# Derivation of a Site-Specific Water Column Selenium Standard for Lake Koocanusa.

**September 2020**

Water Quality Standards & Modeling Section  
Montana Department of Environmental Quality  
1520 E. Sixth Avenue  
P.O. Box 200901  
Helena, MT 59620-0901

**Figure 7. Cumulative distribution of empirical selenium concentrations in fish ovary samples collected from Kooconusa Reservoir and comparison to genus sensitivity distribution of egg/ovary selenium concentrations used to derive the USEPA egg/ovary selenium criterion.**

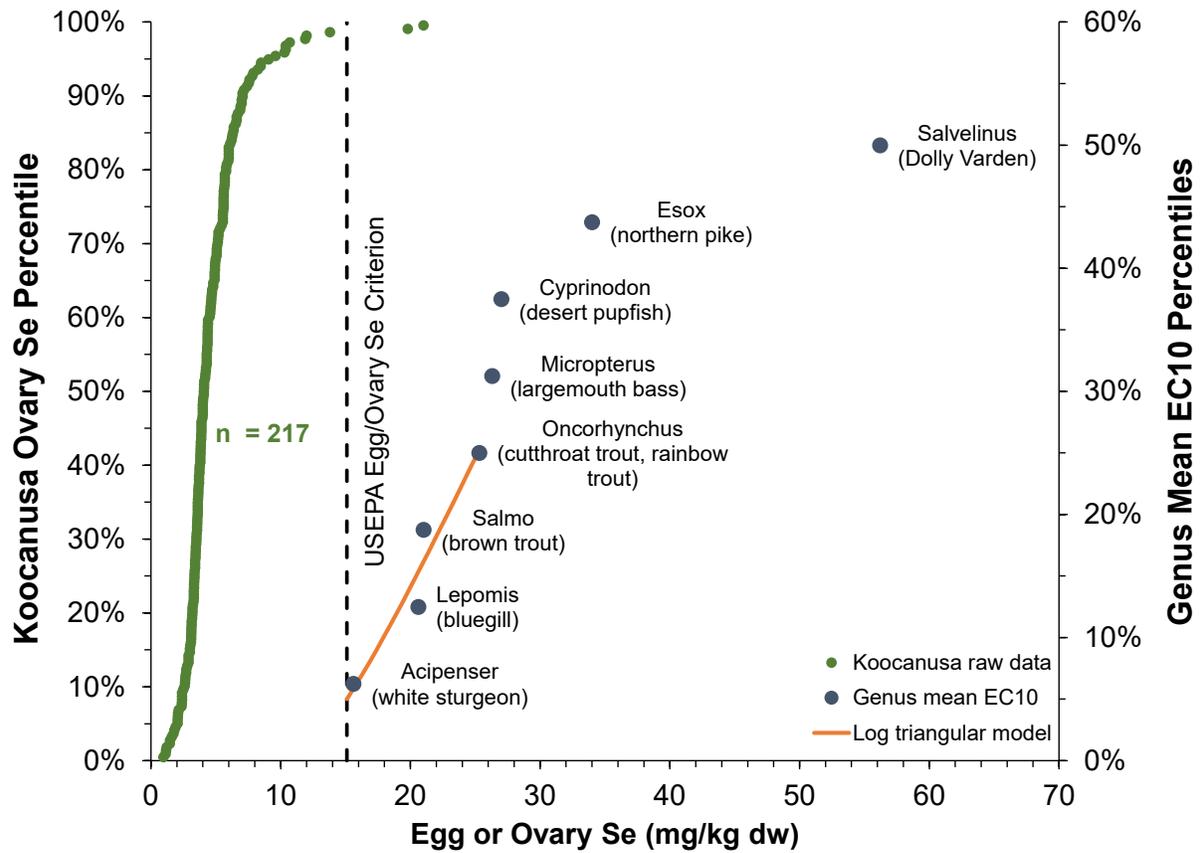
Out of more than 1,200 individual samples of non-cyprinid fish species in the reservoir, there have been only three measurements (0.2%) that exceeded criteria. These include two ovary selenium measurements (Figure 7) and one muscle selenium measurement (Figure 8). No exceedances of the whole body selenium criterion have been observed (Figure 9). For each of the aforementioned individual selenium criteria exceedances, mean selenium concentrations from other samples of the same species, from the same location and time did not exceed criteria:

**Figure 19. Comparisons of predicted and observed whole body selenium concentrations in Kocanusa Reservoir fish.**  
 Note: See text boxes within each panel for the species, tissue type, sample location, and sampling data.

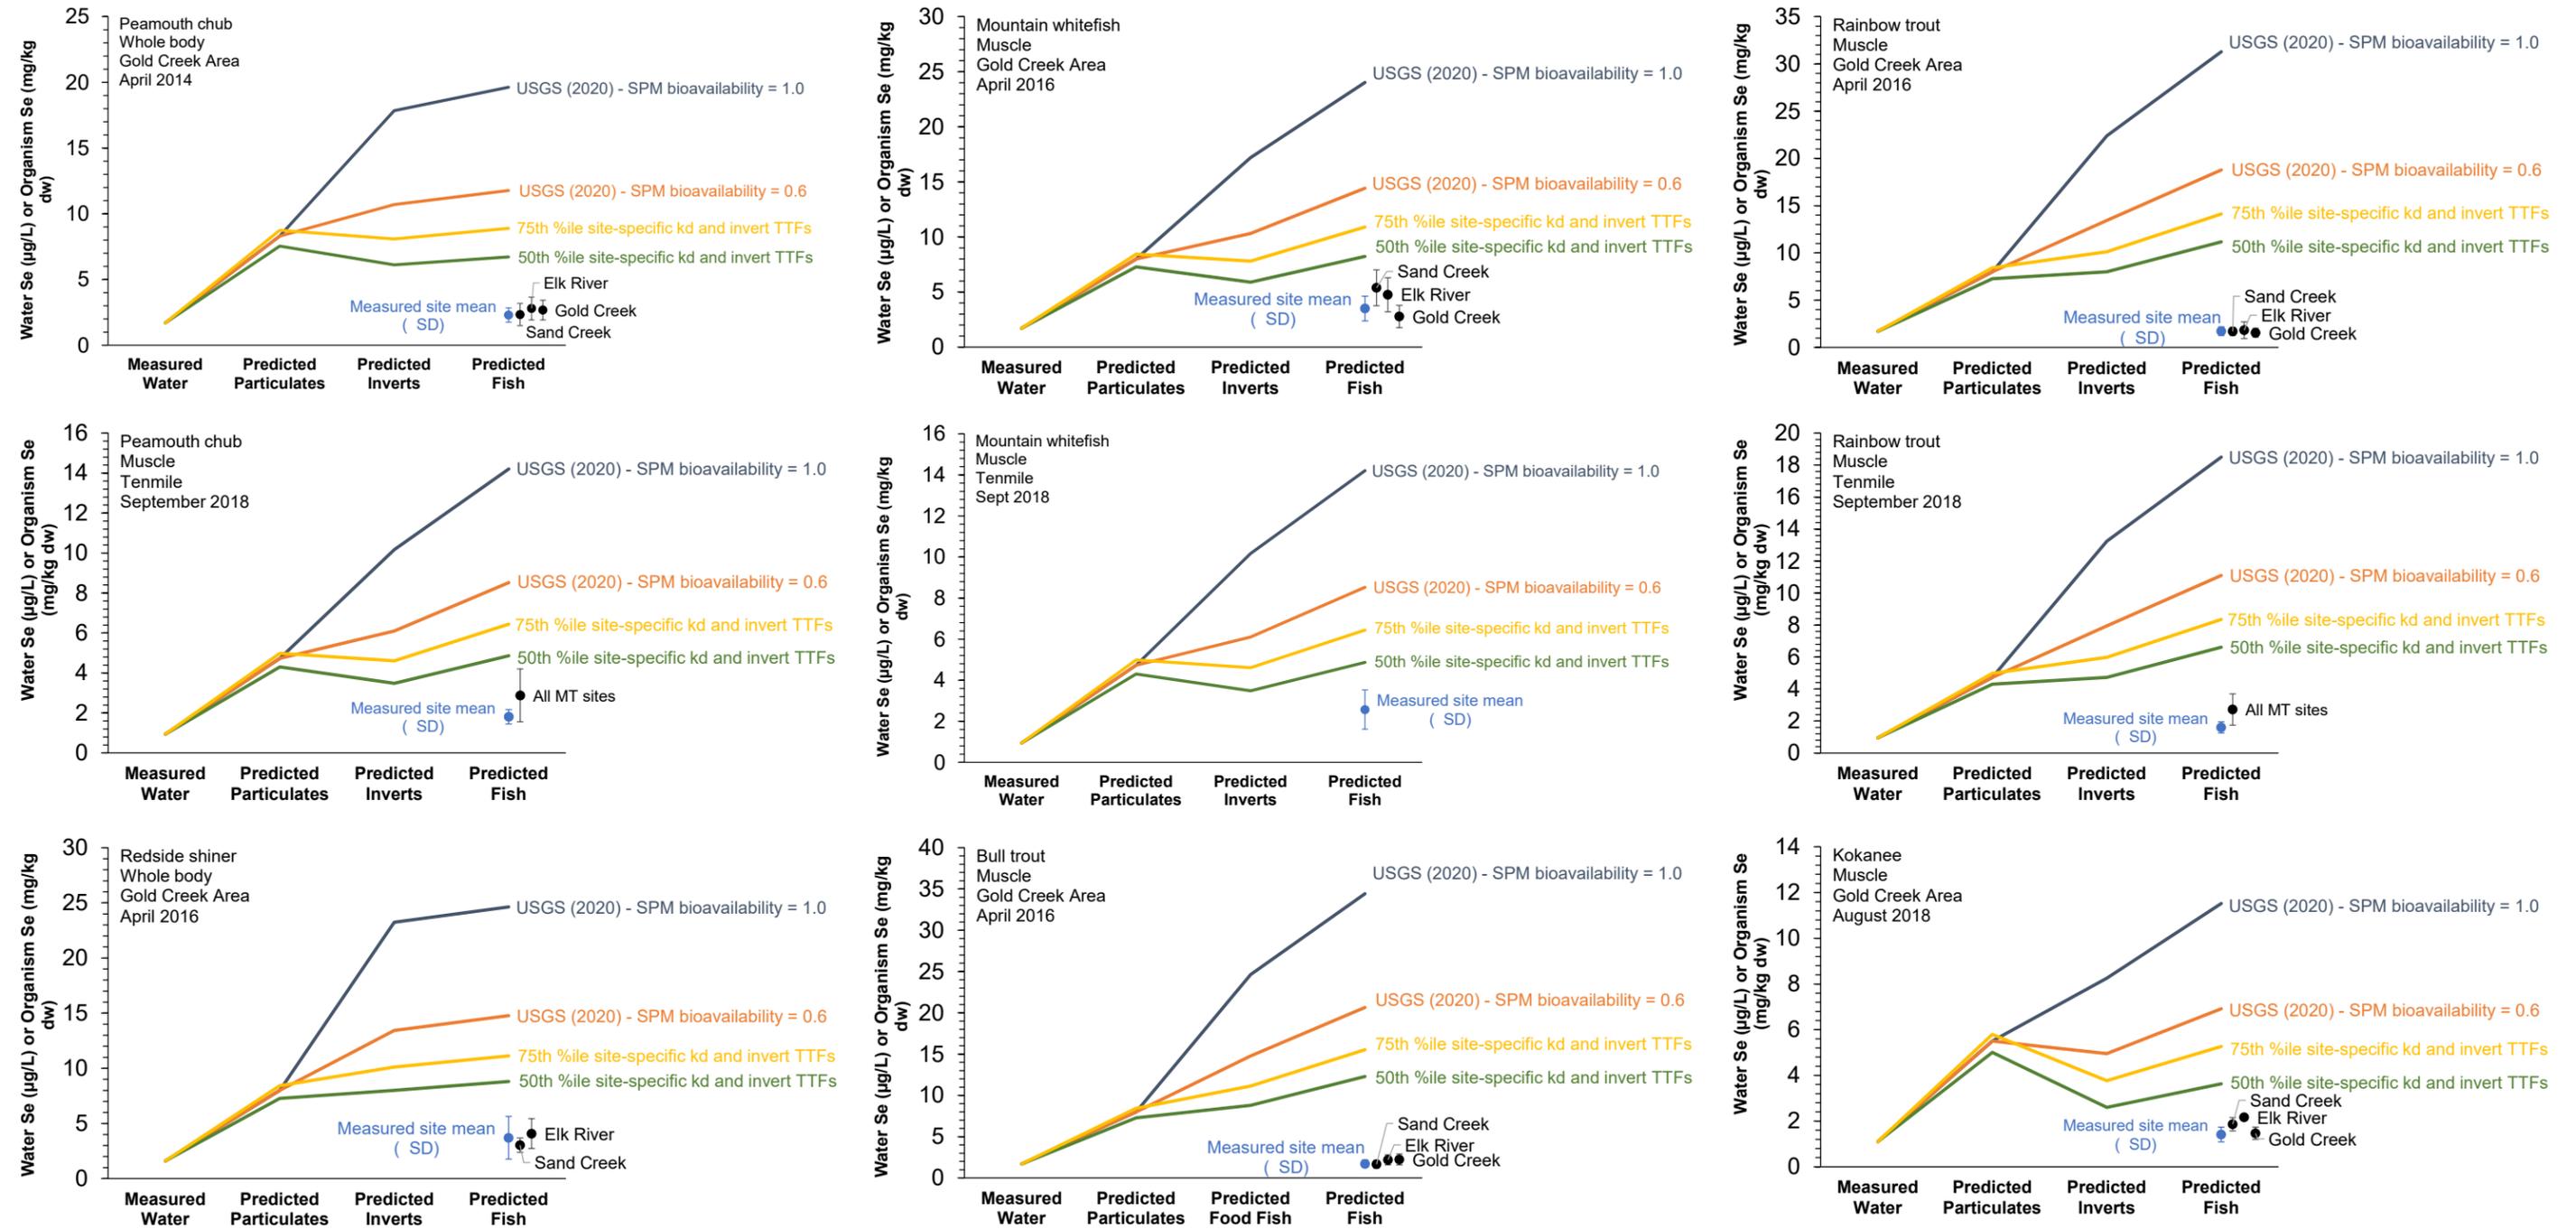
Over the validation scenarios evaluated, measured muscle and whole body selenium concentrations were consistently over-predicted by the USGS model regardless of model assumptions (Figure 19). Based on the USGS model with the 60% bioavailability assumption, predicted fish selenium concentrations were over-predicted, on average, by a factor of 5.0 (Table 4). In most of the scenarios evaluated, this resulted in muscle and whole body selenium concentrations that were predicted to exceed the muscle selenium criterion of 11.3 mg/kg dw and whole body selenium concentration of 8.5 mg/kg dw, while measured fish selenium concentrations were generally less than 50% of criteria concentrations. Even when considering site-specific k<sub>d</sub> summary statistics and site-specific invertebrate TTFs the USGS model predicts muscle and whole body selenium concentrations that, on average, are a factor of 2.9 greater than observed (Table 4).

**Figure 1. Selenium concentrations in the Elk River at HWY 93 crossing with EPA’s recommended selenium criterion for lentic waters for comparison.**

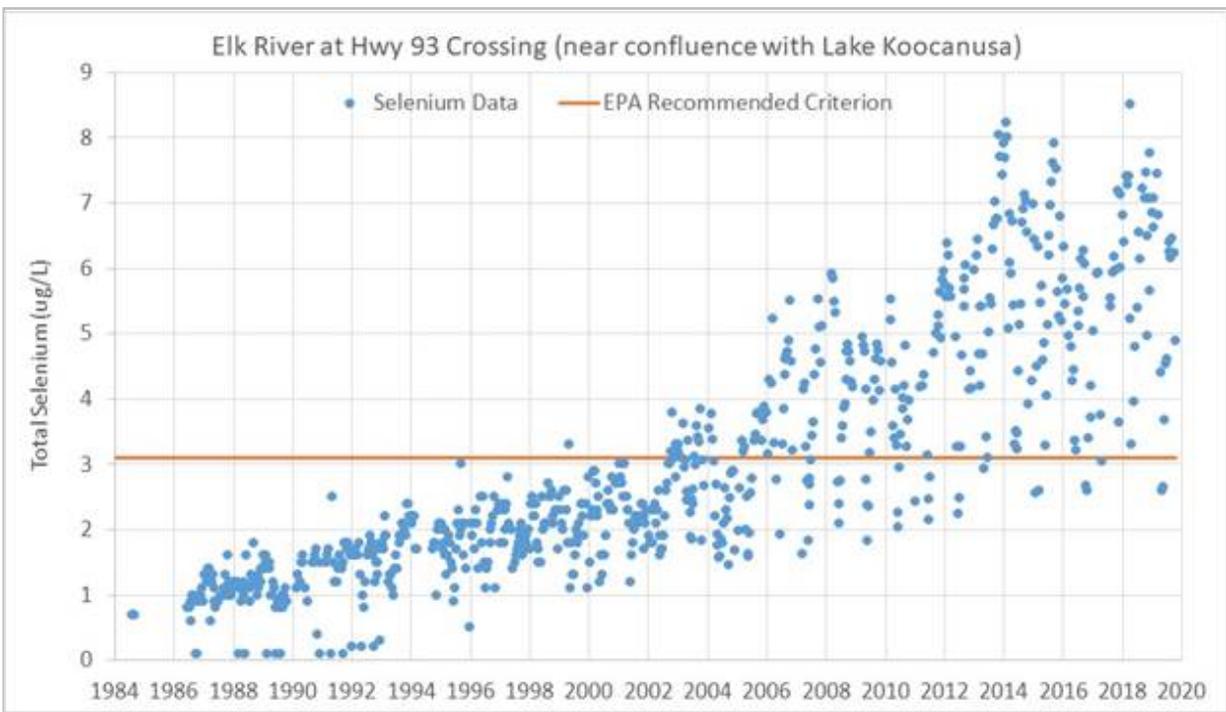
I note that it is seven years since B.C. ENV issued Ministerial Order #M113, which states that, “the Minister of Environment wishes to reduce calcite formation and to manage water quality to stabilize and reverse increasing trends in the water contaminant concentrations.” Despite this order, pollutant concentrations and loads continue to increase into Lake Koocanusa, as demonstrated at the B.C. water quality monitoring site located at the Elk River Hwy 93 Crossing (Figure 1). This information is alarming and highlights the need to immediately stabilize and reverse pollutant loads into Lake Koocanusa.

**Figure 1. Monthly Average Total Selenium Concentrations as Recorded at the Mouth of the Elk River by Environment and Climate Change Canada.**

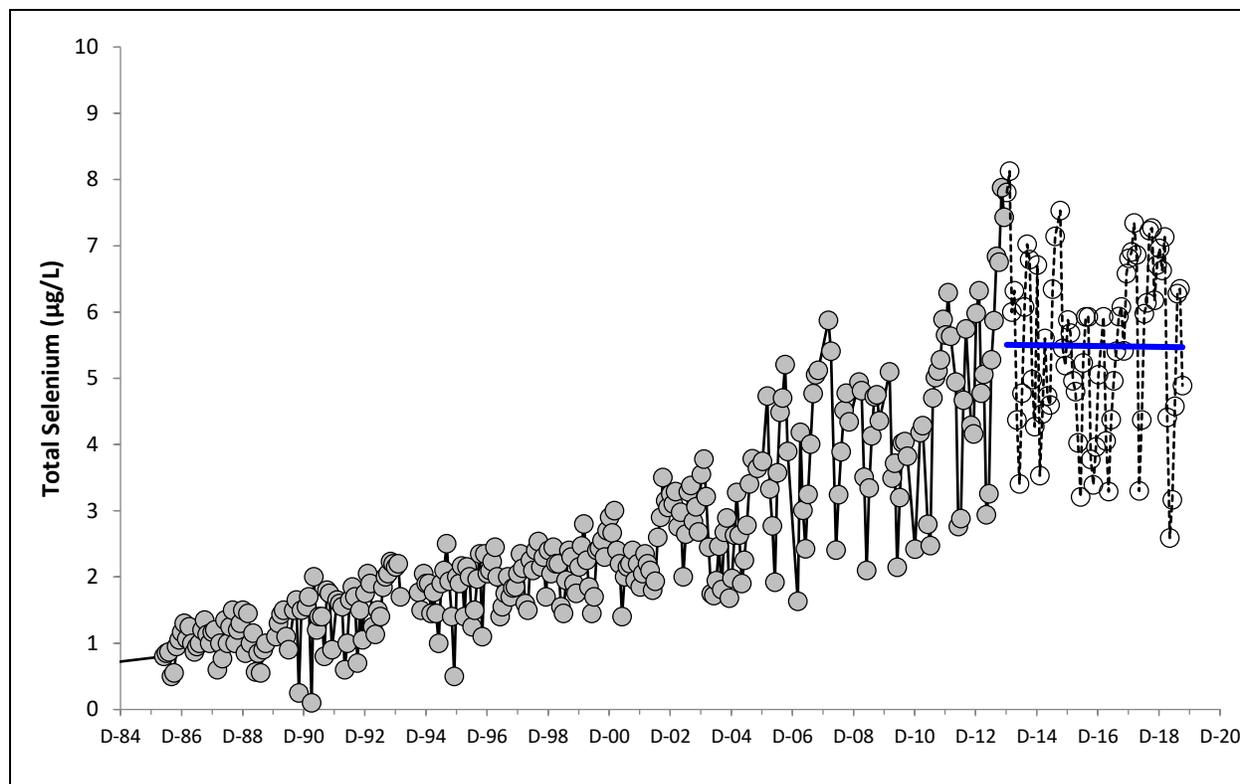
As noted by Presser and Naftz (2020), aqueous selenium concentrations measured at the mouth of the Elk River above Highway 93 (BC08NK0003)<sup>4</sup> have increased during the period of record, but incorrectly identify this trend as *continuing* to increase. Rather and as illustrated within Figure 1 below, selenium concentrations at the mouth of the Elk River have not increased since 2014. On the contrary, not only have selenium concentrations stabilized but a negative slope for the best-fit linear regression line suggests that concentrations are decreasing. This trend is wholly consistent with the goals and intentions of the Area Based Management Plan to “stabilize and reverse increasing trends in water contaminant concentrations”. Furthermore, the suggestion that selenium loads are and will continue to increase is not supported by data.

**Figure 2. Selenium Loads associated with the Elk River into Lake Koochanusa.**

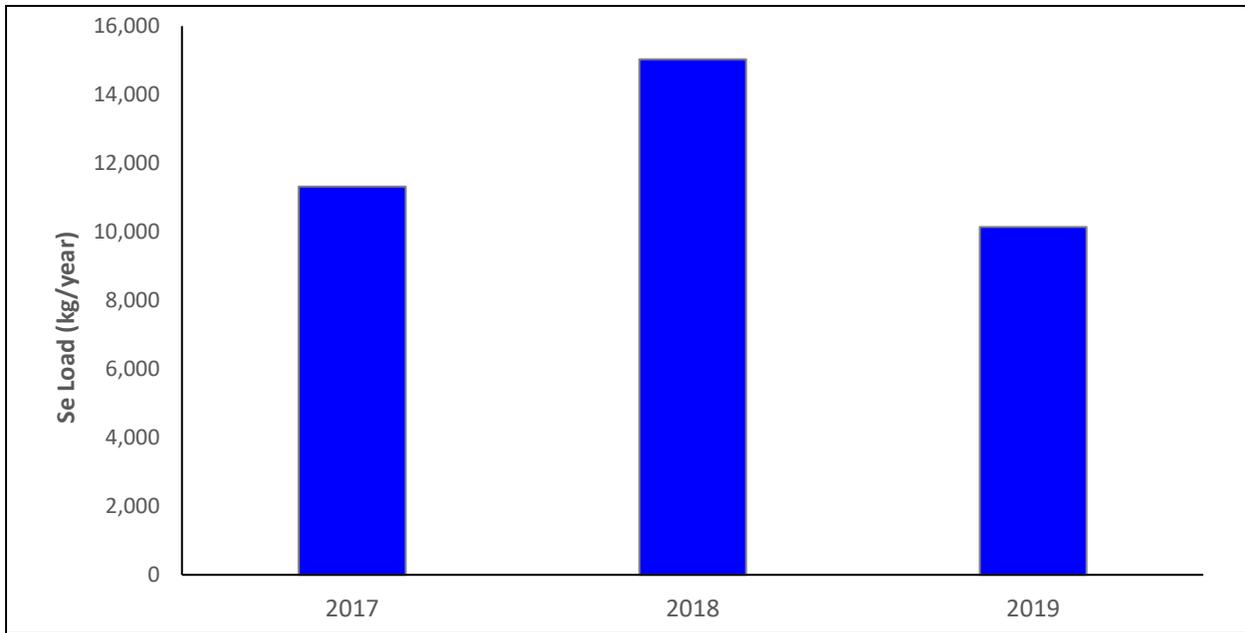
Annual selenium loads from the Elk River into the reservoir have not been increasing and are inconsistent with gradient maps presented within the report. Presser and Naftz (2020) suggest that cumulative cross-sectional areas with selenium concentrations greater than 1 µg/L have increased three- (from 2017 to 2018) and four-fold (from 2017 to 2019) due to increasing selenium loads from the Elk River. Selenium concentrations (see Figure 1) and loads (see Figure 2) from the Elk River are inconsistent with the aforementioned suggestion.
